Reply on RC1:

Reply on RC2:

Figure S2: (a) Calibrated hourly ethane data from Aeris MIRA Ultra instruments (serial number A778 and A798) at CAO over the time period of June 2024, and (b) the difference of ethane between these two Aeris MIRA Ultra instruments.

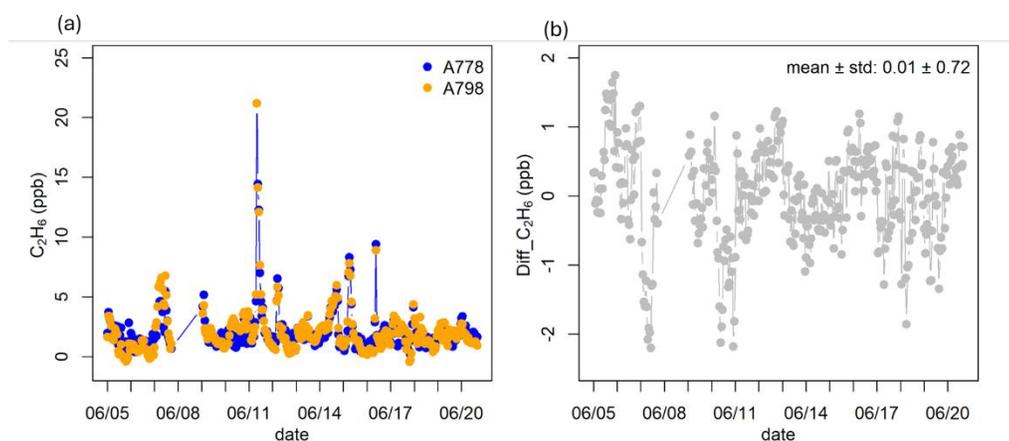
The introduction is easy to read with appropriate background information included. The introduction (line 61-62) and the title of the paper suggest that a large part of the novelty of this study is the laboratory and field assessment of MIRA Ultra for a long-term, tower-based network of both dry methane and ethane. The author understands that the collocated measurements of methane and ethane are important for distinguishing thermogenic methane emissions from total methane emissions. The preprint, however, does not adequately demonstrate confident tower-based ethane measurements.

We unfortunately do not have other continuous (measurement frequency $\sim < 5$ s) instruments with ethane measurements available for a long-term comparison in the field. We did have two Aeris instruments co-located at CAO for about one month (June 2024). These instruments have different noise levels (based on Allan-Werle deviation tests), different water responses, and they were calibrated with separate cylinders. Although it would be preferable to compare the result to a known instrument, the comparison between the two Aeris instruments is quite independent (with results as shown below). The mean difference of ethane was well within the goal of 0.3 ppb C_2H_6 . The instruments were calibrated every three hours and showed a relatively higher standard deviation (i.e., if we were to re-do this knowing what we now know, we would do hourly low cylinder calibrations). The figure was added to the supplementary material. We added a sentence to the methods (Line 263 on page 10): “Additionally, we deployed two Aeris instruments with separate calibration cylinders at CAO for about one month in June 2024.” We added a sentence to the results: “The mean difference of ethane for two independent Aeris systems deployed at CAO for June 2024 was 0.01 ppb C_2H_6 (Figure S2).” was added to Line 417.

Figure Caption: Absorbance simulations for a 15 m pathlength, sampling cell pressure of 240 m bar and a temperature of 42°C. HITRAN 2020 absorption parameters of methane and water were employed in these simulations with Harrison ethane absorption parameters (not incorrect HITRAN values).

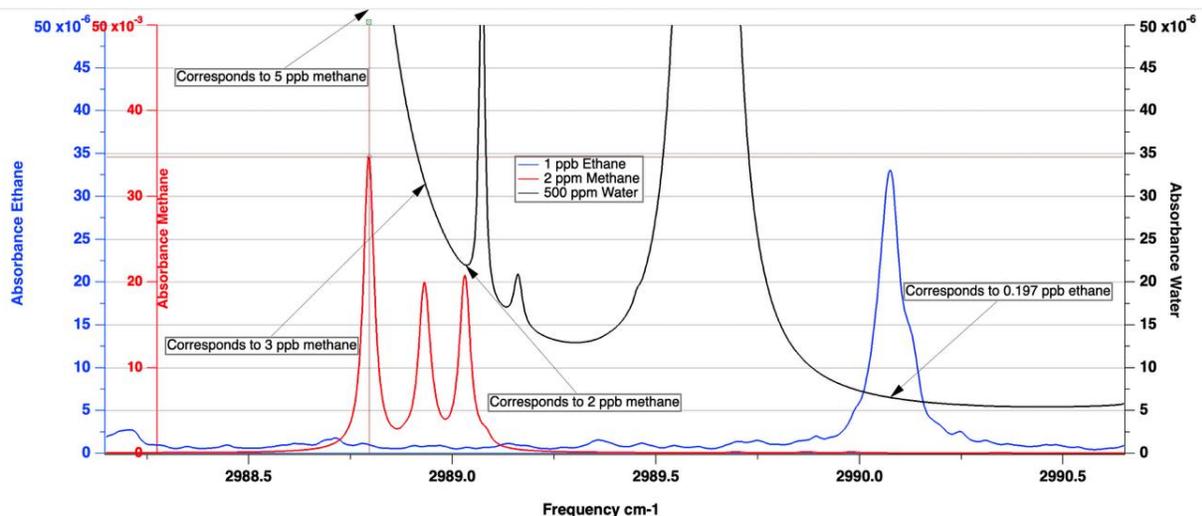
This study represents a good first step in attempts to characterize the AERIS instrument performance for methane and ethane concentration measurements. The ultimate goal of this study is to assess the suitability for a suite of 4 AERIS instruments to be employed in a regional tower based flux study over the Denver-Julesburg Basin (DJB) as shown in Fig. 2. **This reviewer recommends publication of the methane results after major revisions, as discussed below. The ethane results, however, are more problematic and will require additional data and validations. Instead I would bill the AERIS ethane measurements as a work in progress requiring further validation.** This study rightfully places a large emphasis on the interference due to water vapor, and more specifically on how differences in water vapor between calibration and measurement cycles can result in biases. The 10-day laboratory comparisons of the retrieved AERIS methane concentrations from all 4 tested instruments with a Picarro instrument (Fig. 7) presents convincing evidence for the long term AERIS accuracy. The uncertainty due to errors in the water vapor correction between measurement and calibration in Section 3.1.2 is reasonable and in rough agreement with my simulations below based upon the known specific wavelengths employed. Here I am assuming a sample cell pathlength of 15-m (should approximate the AERIS pathlength to within 25%), Voigt line shapes employing the stated sampling cell pressure and temperature. The red profile simulates the absorbance for 2 ppm methane, the blue profile simulates the absorbance for 1 ppb ethane, and the black profile simulates the absorbance for 500 ppm water vapor (the upper limit claimed for the difference in water vapor between sample and calibration). The shown methane and ethane absorbances are for 0 water and the actual spectra will reside on top of the water feature. The indicated water interferences are based on the ratio of peak absorbances (assuming that's what the AERIS software uses). If the AERIS software uses the integrated absorbances, these water vapor interferences may be slightly different. Assuming the former, this simulation shows a water interference of 0.197 ppb for ethane, which is not too different than your 0.15 ppb value. The interference on the red methane very much depends on which of the 3 lines that are employed by the AERIS software. The average interference using all 3 lines is approximately 3 ppb, which matches your upper range. The above simulations reveal a number of important features. First the absorbance (-lntransmission) for 1 ppb ethane is approximately 3 orders of magnitude weaker than ambient methane levels around 2 ppm. Secondly, the water vapor correction will dramatically be affected by the Nafion scrubber performance. Even small changes in this performance will adversely affect the measurement accuracy. Thirdly, as can be seen, the water vapor tail around the ethane line is relatively flat but the features around the 3 methane lines are steeply sloping. Hence, the water vapor interference on methane will be more dramatic than ethane, as borne out by your Fig 3 plots. **This reviewer thus strongly recommends that water vapor concentrations need to be retrieved along with the methane and**

ethane values to assess in real time the Nafion scrubber performance in order to effect corrections. To the degree possible, this reviewer also recommends a close examination of the software fitting algorithms and parameters employed. Specifically, are the methane results based on one, two, or all three lines, and what are the absorption parameters employed (line positions, absorption and broadening coefficients, etc.)?

Thank you for the general comments and the detailed analysis. We really appreciate it. It's great to see that the water vapor effects we see are in the expected range based on your analysis. In fact, water vapor concentration was retrieved along with the methane and ethane values by the Aeris instrument. We added a phrase in Line 103 to clarify that point, "Typical differences between the dried sample and the humidified calibration gas, as measured by the Aeris instrument, were 100 - 500 ppm H₂O." We do have real-time water vapor concentrations used in this study to assess the Nafion scrubber performance and we assess the uncertainty related to the water vapor for each hour based on these values.

The software fitting algorithms are not open source, but we did get the following information from the manufacturer that "All three of the methane peaks are fitted and used to calculate the end concentration, they are weighed equally." We added the sentence, "In the wavelength range of the instrument, corresponding to frequencies of 2989.2 to 2986.4 μm, there are three methane peaks, and all are weighted equally to determine the mole fraction." to Line 73.

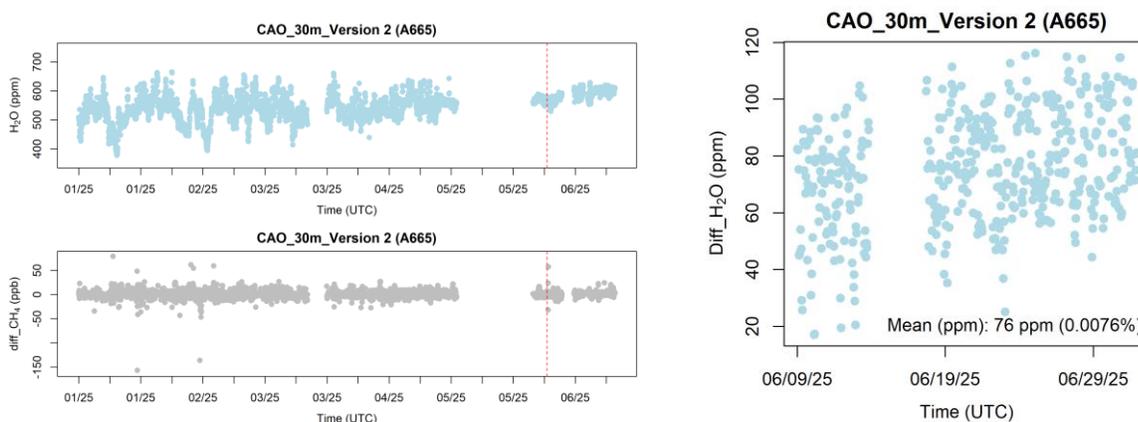
Line 258: Is it valid to ignore data with “large” atmospheric variability as detected by the Picarro? I am aware that this presents challenges in terms of precise timing and residence time issues, but large ambient swings could provide important additional tests of the AERIS instrument with potential large swings in water vapor. I would recommend trying to reanalyze these time periods if possible.

It was mentioned at Line 254-259 that “The NOAA Picarro line was flushed with an additional pump with a high flow rate such that the sample air takes only several seconds (8 - 14 s) to reach the instrument and the data were reported as 2-min means every 15 min. The Aeris instrument analyzed air from 30 m AGL using a dedicated sampling line. The flow rate for the Aeris was controlled at 110 sccm, using only the pump for the instrument. With this flow rate, the air took about 20 min to travel from the inlet to the Aeris MIRA Ultra. The timing difference was accounted for in the comparison. To minimize noise that might be caused by mismatches in timing, the hours with large atmospheric variability were removed.” Note the response to Reviewer 1, the sentences (Line 258-Line 260) were rewritten as “To minimize noise that might be caused by mismatches in timing, the hours with large atmospheric variability were removed (Levin et al., 2020; Richardson et al., 2017; Miles et al., 2018). We used a threshold of 7 ppb CH₄ for the standard deviation within each hour above which the data for that hour were excluded (Richardson et al., 2017).” Figure 9 was updated as shown below. The standard deviations are a bit larger, but the overall message is the same.

We used the Nafion in the system to dry the sample air. The Nafions react slowly to water vapor changes, providing a relatively stable value. For our current application (calibration every one hour), the difference of water vapor between the sample air and calibration cylinder remains small (below 100 ppm at CAO), and this water vapor difference caused uncertainty was calculated and documented in the data file. Below are the water vapor time series plot (from January - June 2025), the difference between the Aeris and NOAA Picarro CH₄ for that time period, and the difference of water vapor between the sample air and the calibration cylinder (June 2025). The water vapor was relatively stable and did not show large swings in water vapor corresponding to the large variation of methane.
